Texaco Refining
and Marketing Inc

August 1, 1994

ENV - STUDIES, SURVEYS & REPORTS
1127 Lincoln Avenue, Alameda, CA
Addendum to Work Plan

PROPOSED CORING LOCATIONS
Former Bay Street Texaco Station
1127 Lincoln Avenue
Alameda, California

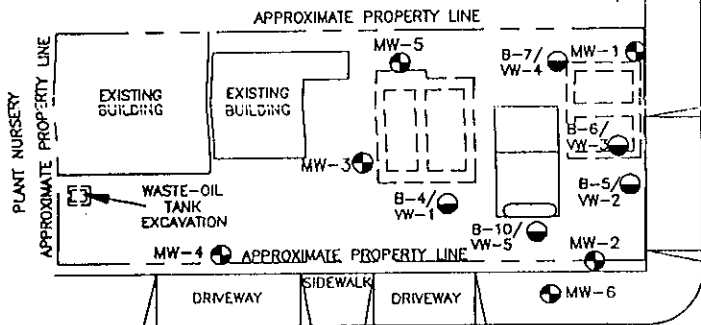
Your concern for the investigation of groundwater immediately down gradient of the known hydrocarbon plume is well taken. Texaco concurs with your suggested location for a down gradient well. A site visit has confirmed the possible well location at 1617 Bay Street you noted.

Direct investigation along the buried utility lines is a dangerous proposition, especially if the sewer lines are of clay pipe materials. Identification of the pipes location close enough to satisfy safety requirements for drilling are difficult. However, to gather additional information for site assessment and indirectly investigate the potential for plume migration along the utility lines, three proposed core-hole locations have been added to gather soil and groundwater data from the east and west sides of Bay Street (See Attached).

3. Upon receipt of the groundwater sample analytical results from the core-hole sampling program, Texaco will have a figure prepared with the proposed location for the three new monitoring wells (two from core-hole location, one at 1617 Bay Street) for submittal in a short well installation workplan for the ACHCSA review and approval.
4. Groundwater monitoring well drilling, construction and installation will be conducted according to ACHCSA requirements, Alameda County Water District permit requirement, and field protocol as presented in the workplan.
